## **Greenway Heights**

### **Project updates since the 3/6/13 COW meeting:**

COW  
MEETING 2

LANDSCAPE  
PLAN

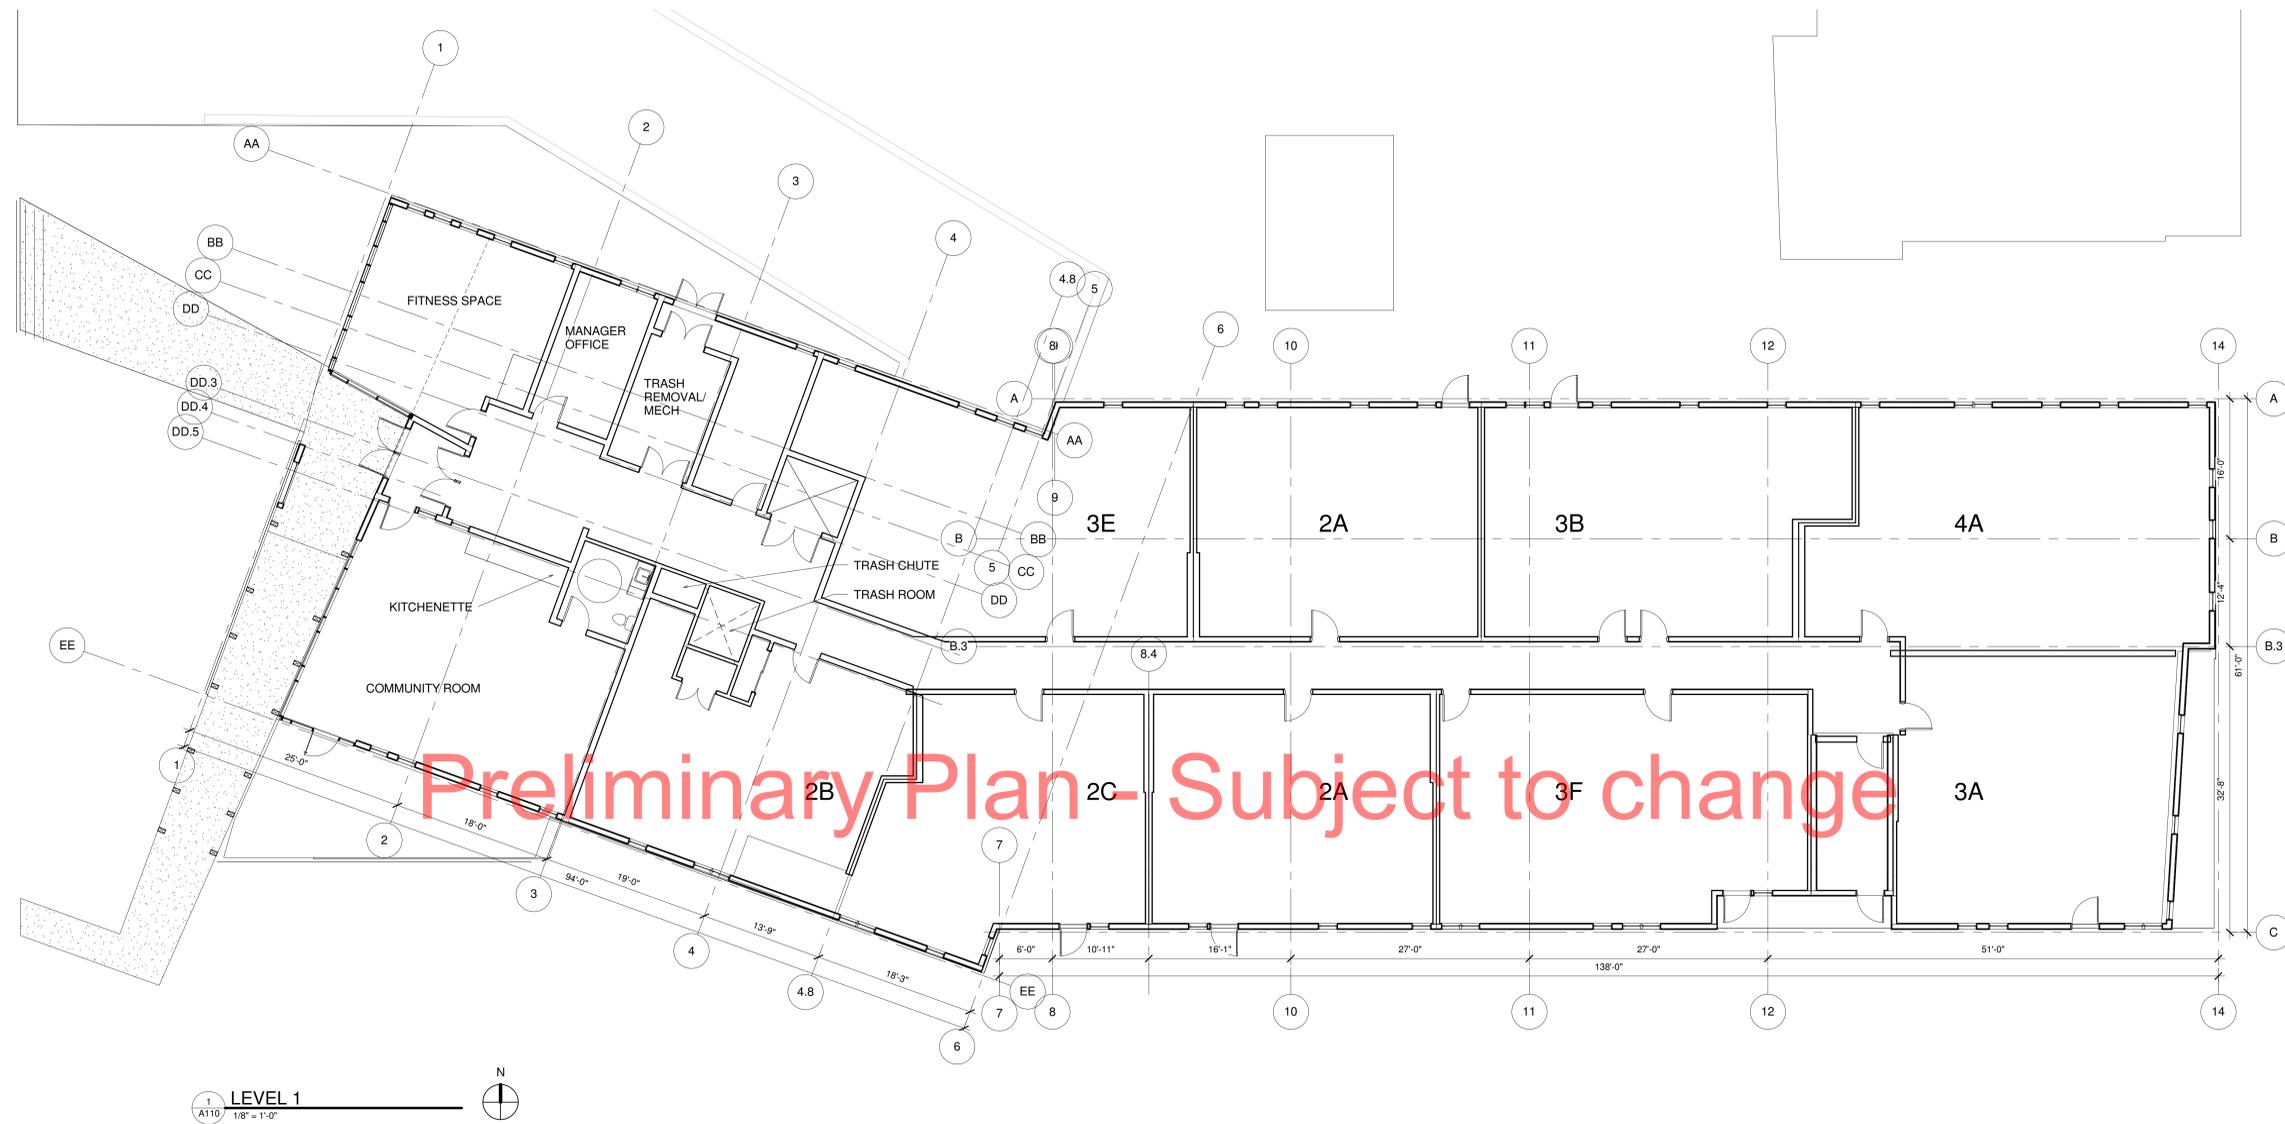
#### **1) Children's play area**

The outdoor play area has been modified in order to comply with the City requirements for minimum size required of 1,300 sf. Calculations are as follows:

Thus, (4) four bedroom units + (22) three bedroom units = 26 units x 50 sq ft/unit = 1,300 sf.

The improved play area is 1,362 sq ft and includes programmed areas for both younger and older kids. Per commissioner comments, there will not be one central piece of equipment in the play area; rather there will be a 12' x 14' mini-court and basketball hoop off to one side, a mini-bocce court, and places for playing hop-scotch, 4-square and similar games. Tables have been placed against the common area glass to facilitate observation by adults. A grill is also located in the space to allow the tables to double as locations for outdoor dining.

#### **3) Site plan**

The promenade gateway arch elements along the Greenway have been eliminated, allowing the pedestrian pathway to appear public in nature, rather than private.

Five raised communal garden beds, 80 sq ft each, have been located along the top of the small retaining wall, allowing for substantial vegetable production for the residents of the complex - <http://www.squarefootgardening.org/>

The entry sidewalk has been reconfigured to keep an appropriate width in the setback and then widen as it gets closer to the building. The bike racks have been relocated near the front entry.

ELEVATIONS-SOUTH  
+ WEST

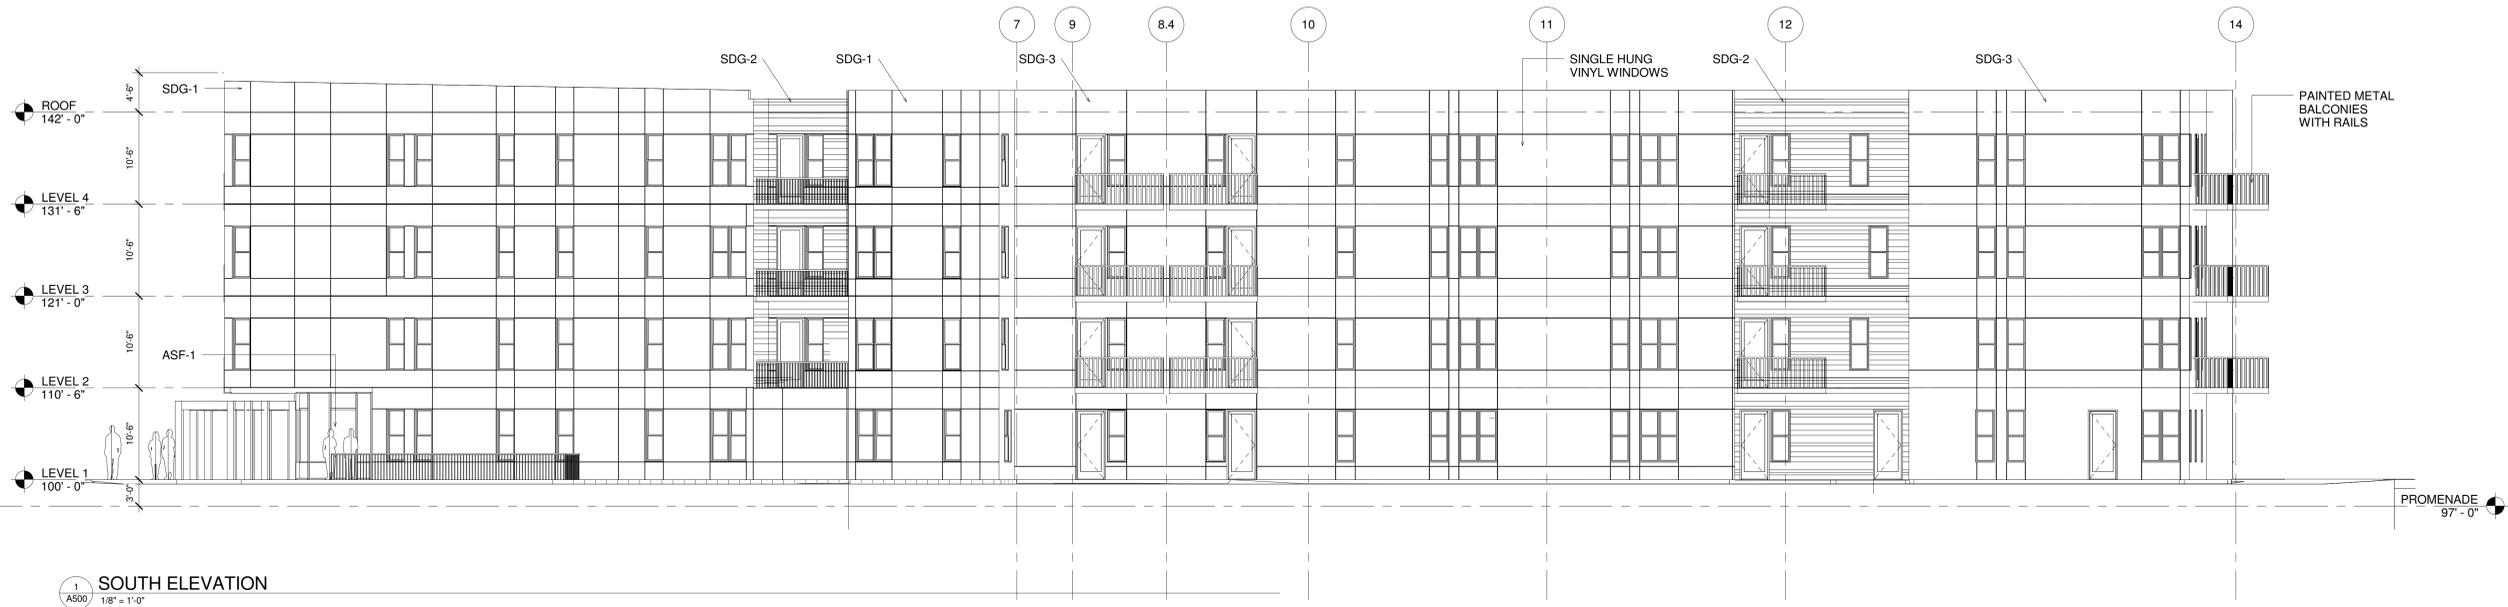
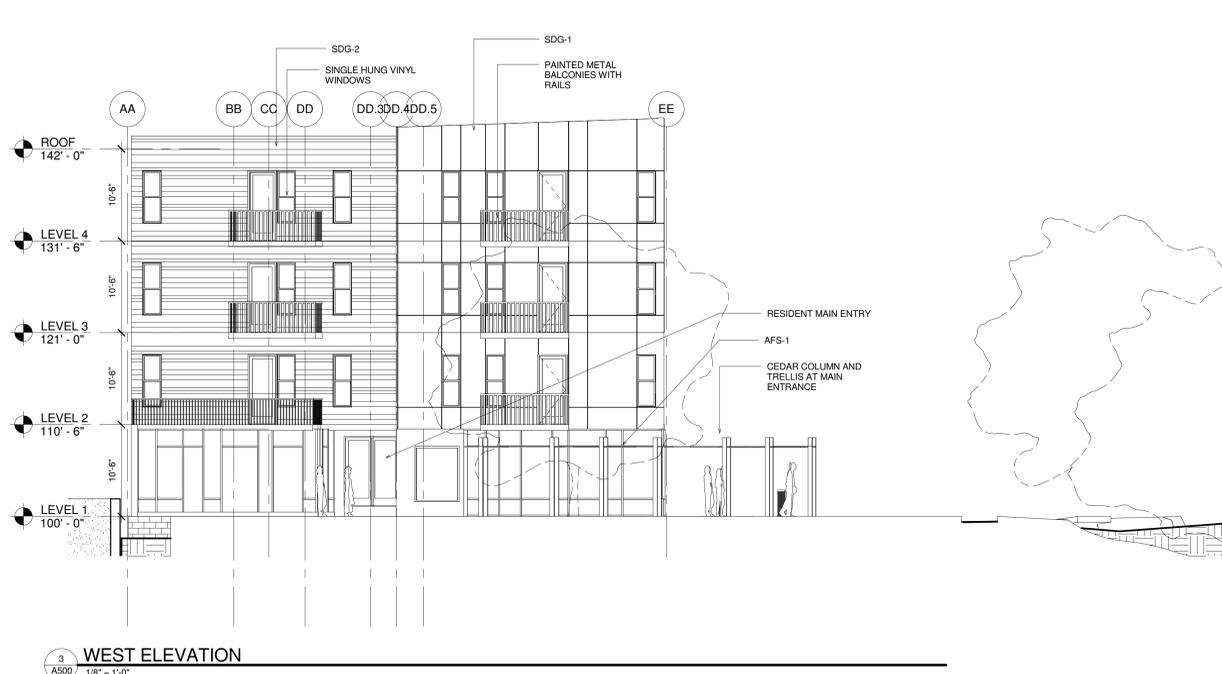
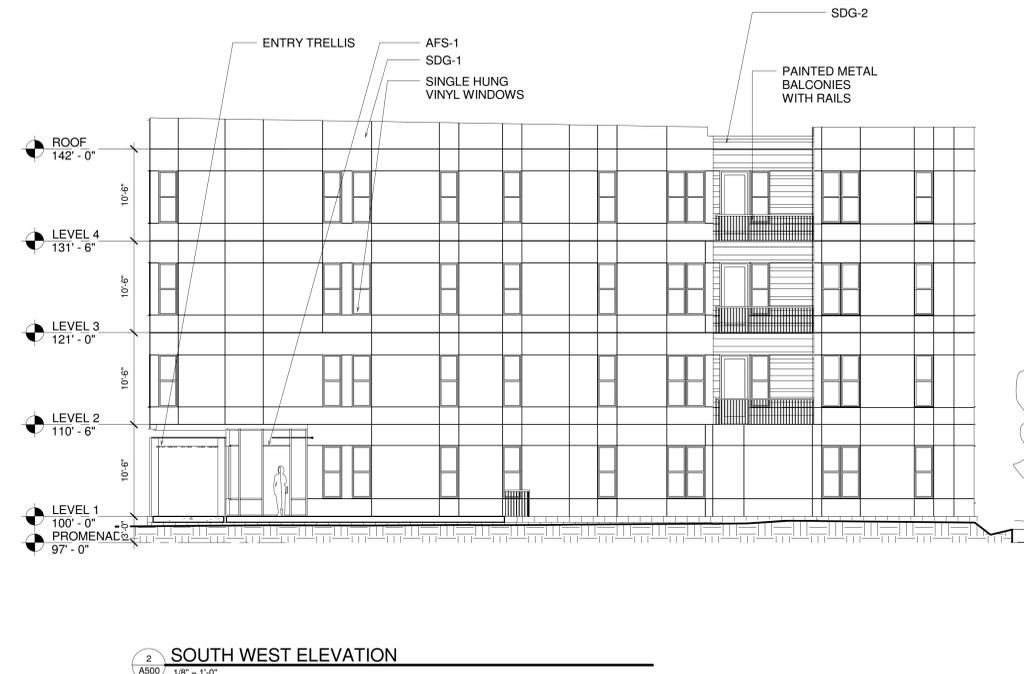
#### **2) Exterior elevations**

All elevations have been updated, based on comments received at the 3/6/13 meeting. Metal panel areas have been increased and coordinated with building's intended design aesthetic. The detailing on the previously shown lap siding has been adjusted to a custom coursing pattern as well as the addition of articulated cornice/edge elements as shown on the elevations

The entry trellis has been modified to extend along the west elevation and is the primary element in the building's formal entry sequence. The cedar posts/beams both soften the building's interface along Bloomington Avenue, as well as induce a rhythm of movement into the building's primary public space.
